APPENDIX 02
Design Officer Clarifications

Design Officer Clarification Comments

for Planning Application SDNP/20/04118/FUL, Appeal Reference: APP/Y9507/W/21/3289423

Figure 1: Relative footprints of existing and proposed buildings

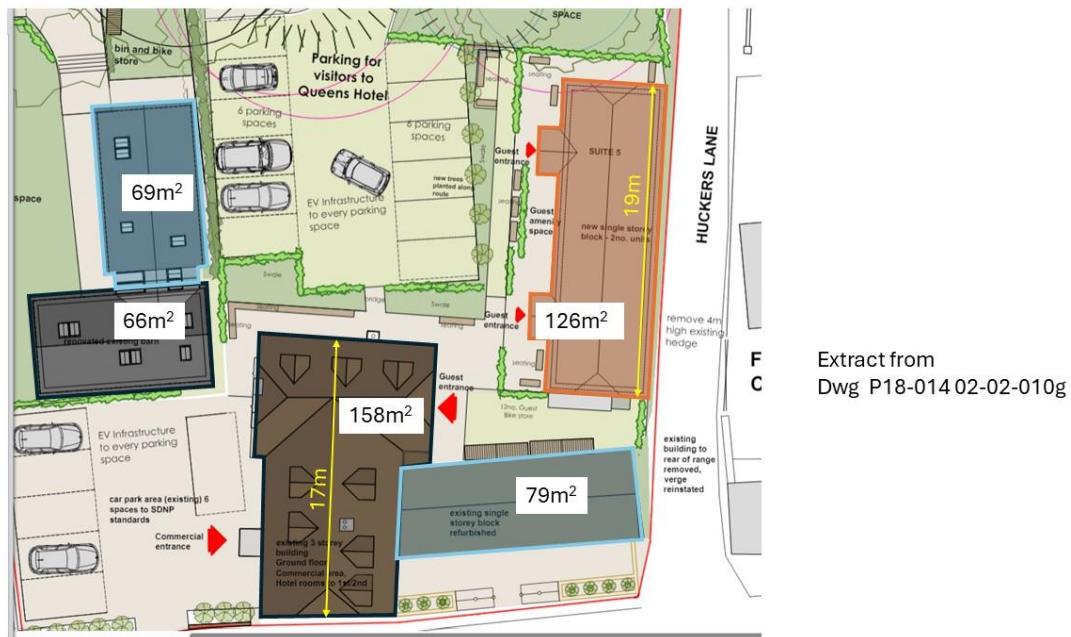
This (shown in red on figure 1) is too large for what should read as an ancillary building to the main building and to the extension to the main building as part of the characteristic hierarchy of buildings in Selborne. To illustrate this, figure 1 shows the relationship between the original main building (footprint approximately 158m²) and the existing extension (footprint approximately 79m²) equates to an extension which has a footprint which is 50% of the original main building. Although this is a relatively long extension, this is still proportionate and respectful of the main building. In contrast, the proposed new building along Huckers Lane (footprint approximately 126m²) has a footprint which is 159% of the extension (80% of that of the main building) and it is also longer than the main building (approximately 19m to approximately average length 17m). Where it is locally characteristic to have a large main building with some extensions and/or modestly sized outhouses, the proposed Huckers Lane building risks competing with the main building and is far bigger than the existing extension, which it should be subservient to.

It is proposed that the existing barn be converted into a residential dwelling and that this barn be extended with a building of the same height and scale. Referring again to figure 1, the proposed extension would represent a 105% enlargement of the original barn footprint. This is not proportionate and is in contravention of Key Design Principle C.4.2c ('Extensions should be subservient to the main building') of the adopted SDNPA Design Guide.
